PZ21-00007 (DEV)
Navajo Lofts (Traffic Impact Analysis Review)
06/17/21

RE: Lee Engineering Responses to 1st Navajo Lofts TIA Review (06/17/21)

Navajo Lofts

Traffic Impact Analysis

Site Traffic Distribution and Assignment

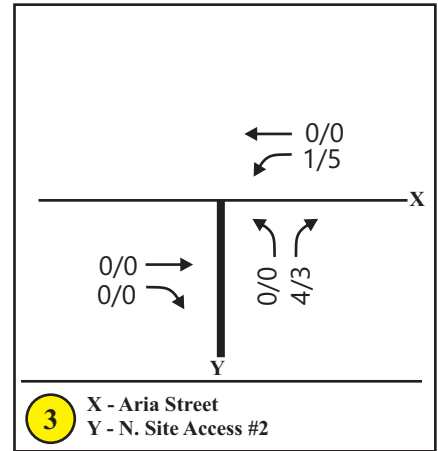
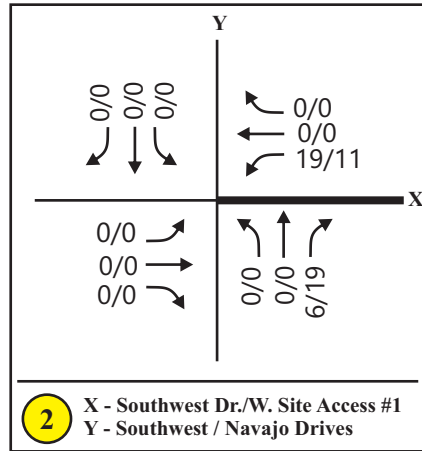
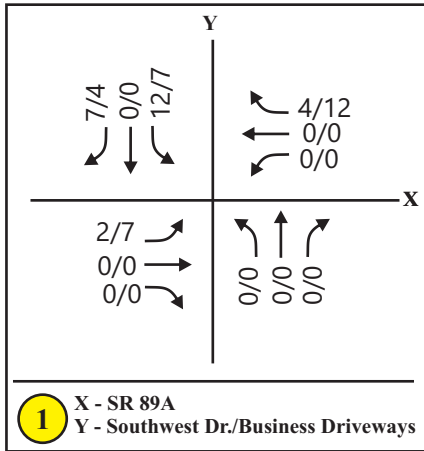
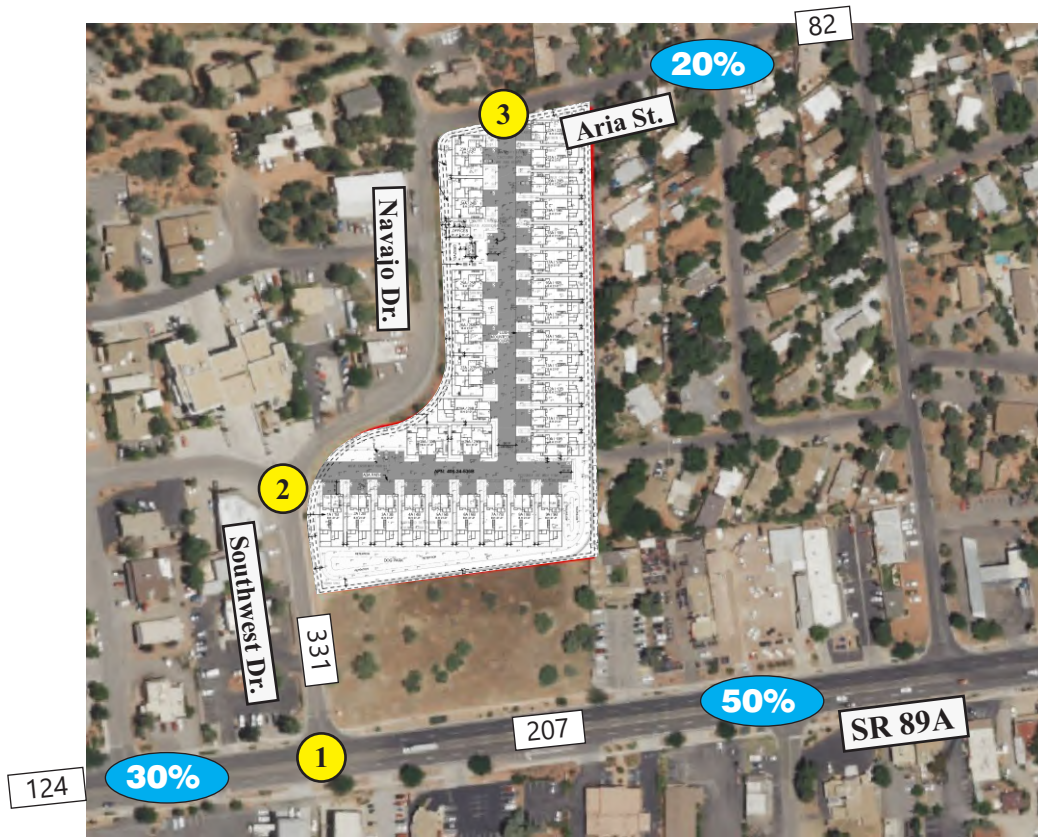
Comment 2. Trip distribution – we find 20% of users to Aria St. high. Please adjust or justify.

Lee Engineering Response: A travel duration analysis was conducted indicating approximately 13% of the site would benefit from using Aria Street, if destined to/from SR 89A east. Including potential delays, 20% of site traffic to Aria Street is reasonable. No changes to distribution percentages were made.
